REVIEW OF THE GRASSLAND BYPASS CHANNEL PROJECT MONITORING PROGRAM

BY THERESA S. PRESSER, MARC A. SYLVESTER,
NEIL M. DUBROVSKY, AND RAY J. HOFFMAN

United States Geological Survey
Administrative Report

DECEMBER 1996

Figure 5. Variations in organic carbon concentration in San Luis Drain sediment within checks 1/2, 10/11, 15/16, and 27/28.

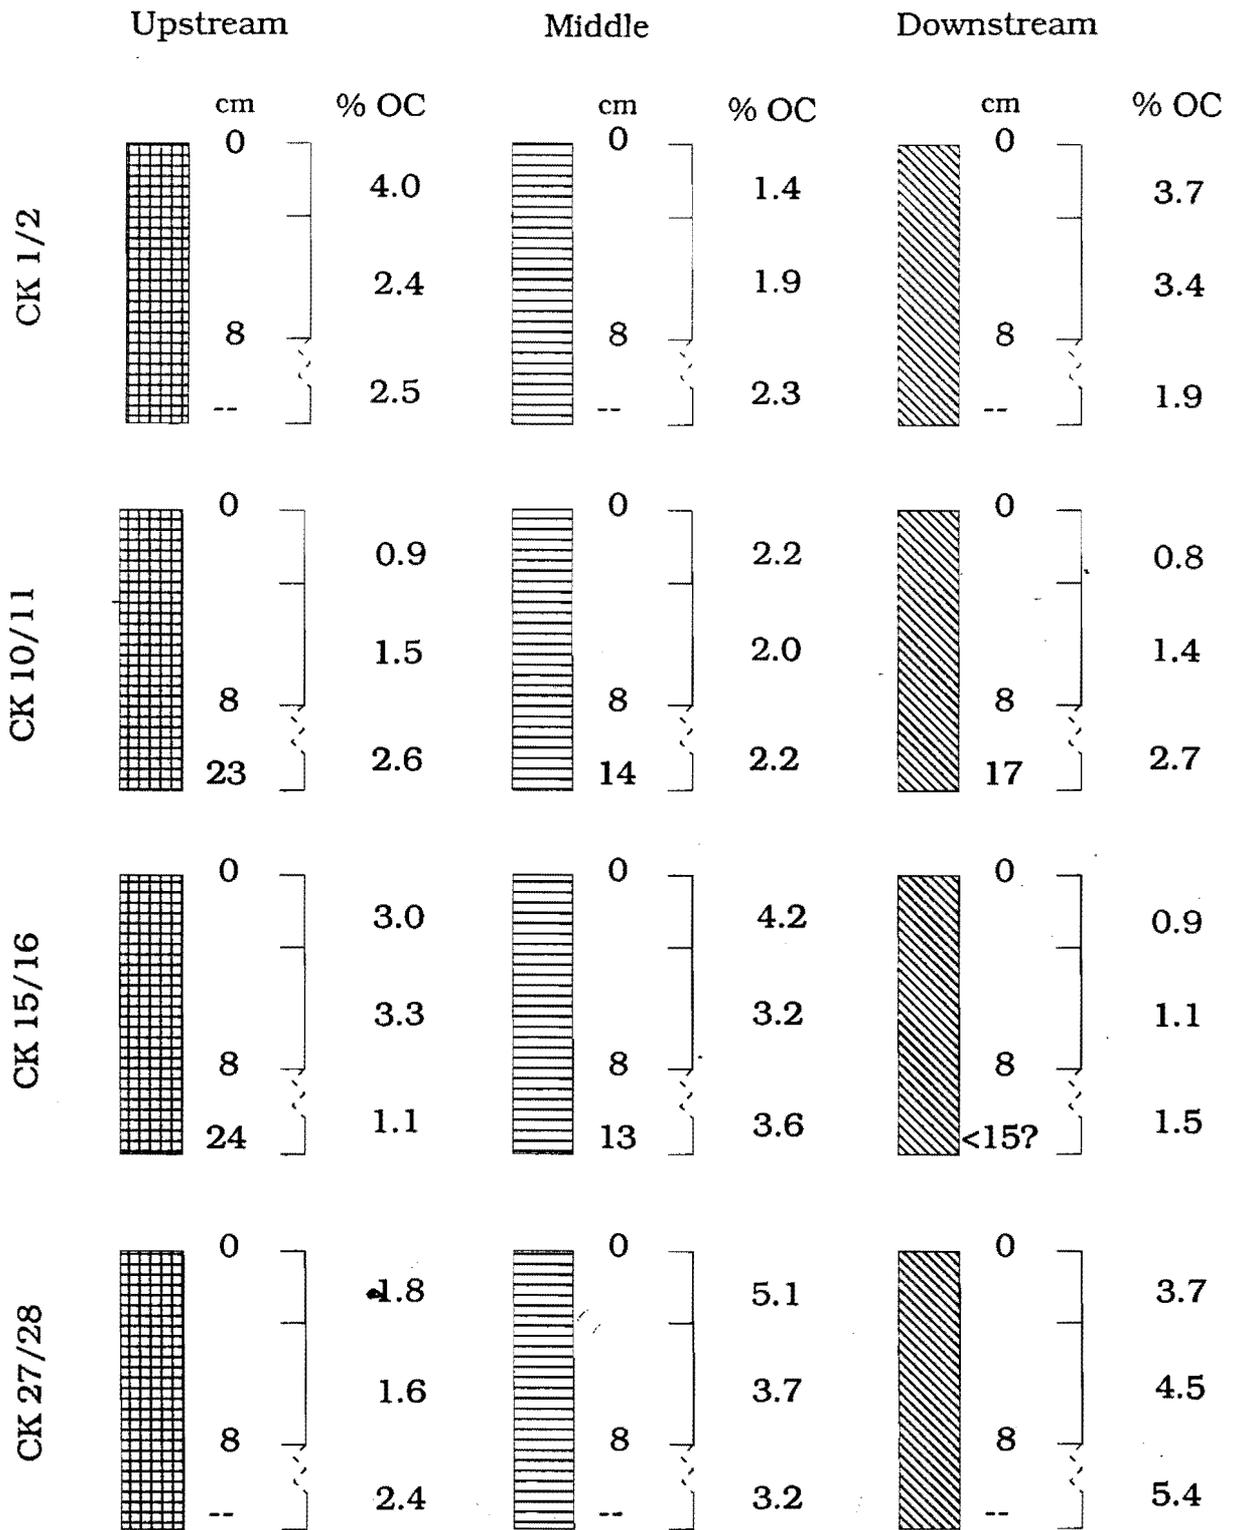
USFWS and presented at the TAC, to detect a 25 percent change in selenium concentration in bed sediment in check 10 given the variability in the concentration, 138 samples would be needed. It was concluded that the sampling schedule used in the initial start-up monitoring plan (check 1-2, check 10-11, check 15-16, check 27-28 for the previously considered 34 miles of the SLD to be reopened) would only show gross differences. To implement a sampling plan to define a smaller increment of change may be cost prohibitive. The variability of organic carbon analyses among and within checks (fig. 5) as mentioned previously, is also great and not readily interpretable.

Figure 6. Variations in boron concentrations in San Luis Drain Sediment within the terminus, check 2, and check 10 (C = composite).

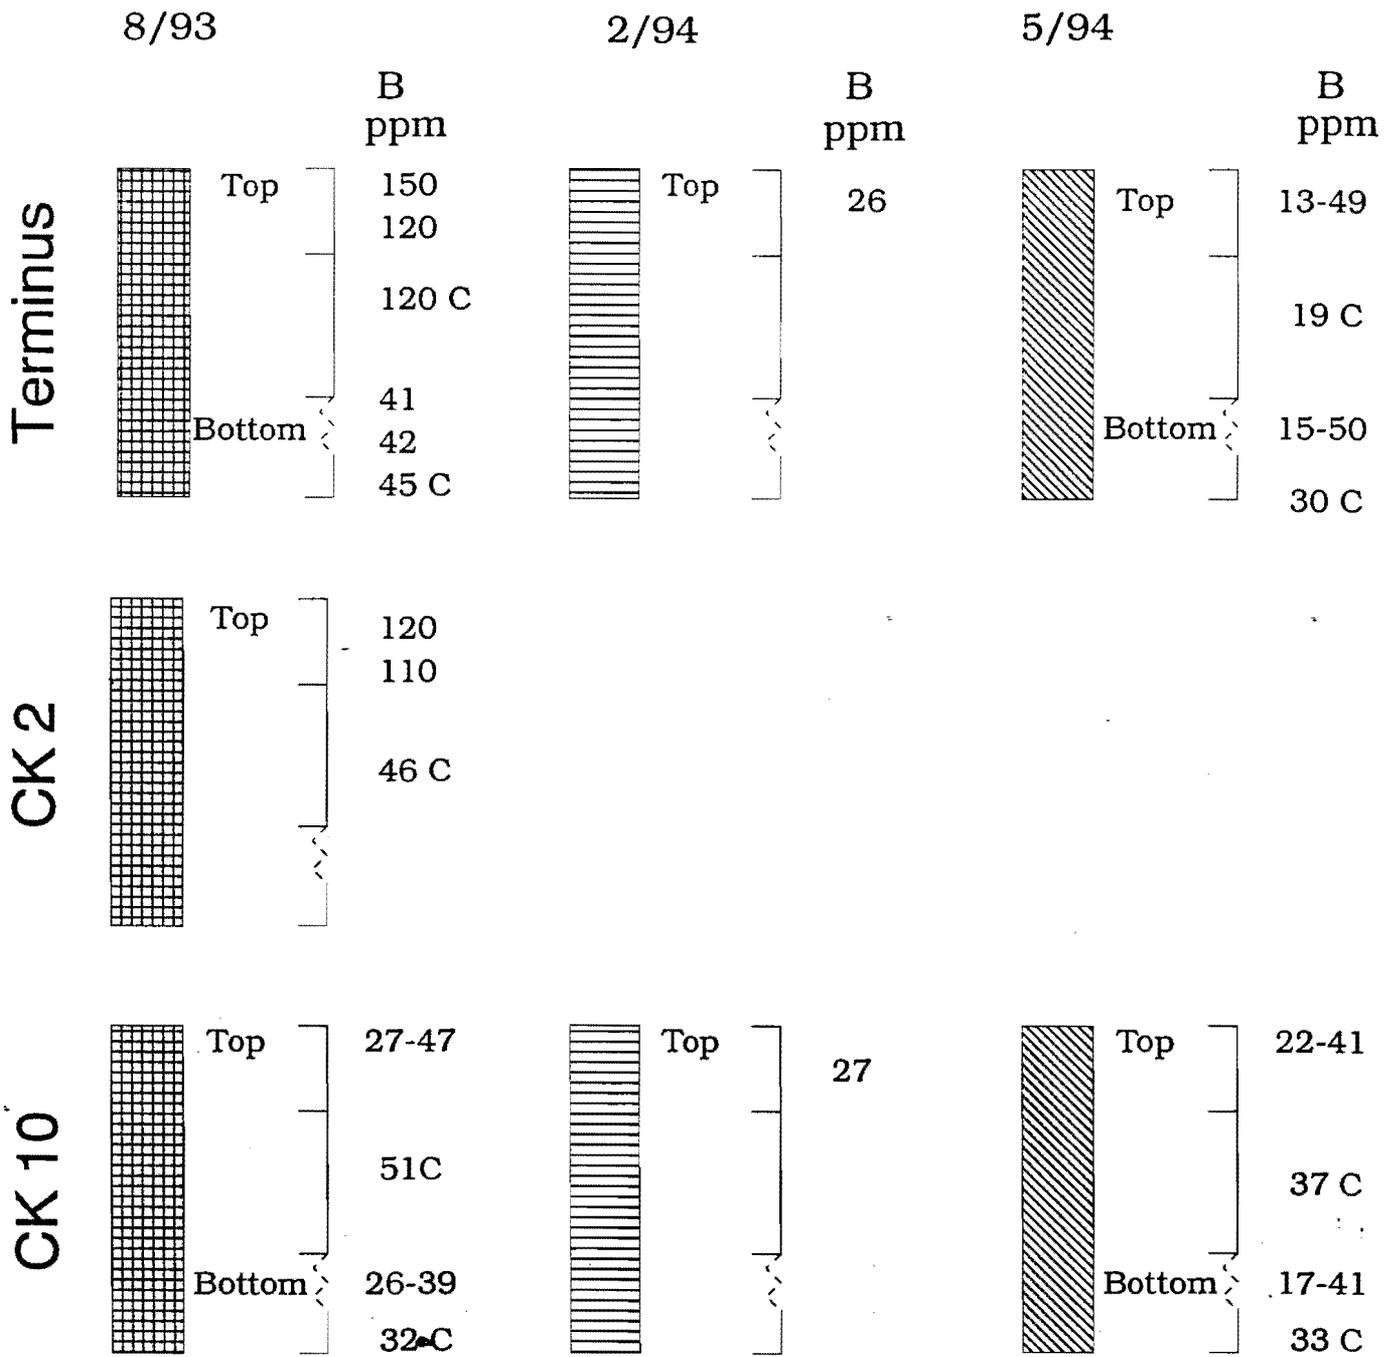
Distribution of boron in SLD bed sediment is shown in figure 6 for sampling surveys completed in 1993 and 1994. The significance of these highly-elevated levels of boron (up to 150 ppm boron) occurring in SLD sediment when compared to a geometric mean concentration for soils in the western United States (23 ppm boron) and the dominant form of boron for transport has not been considered previously in documentation of the SLD.
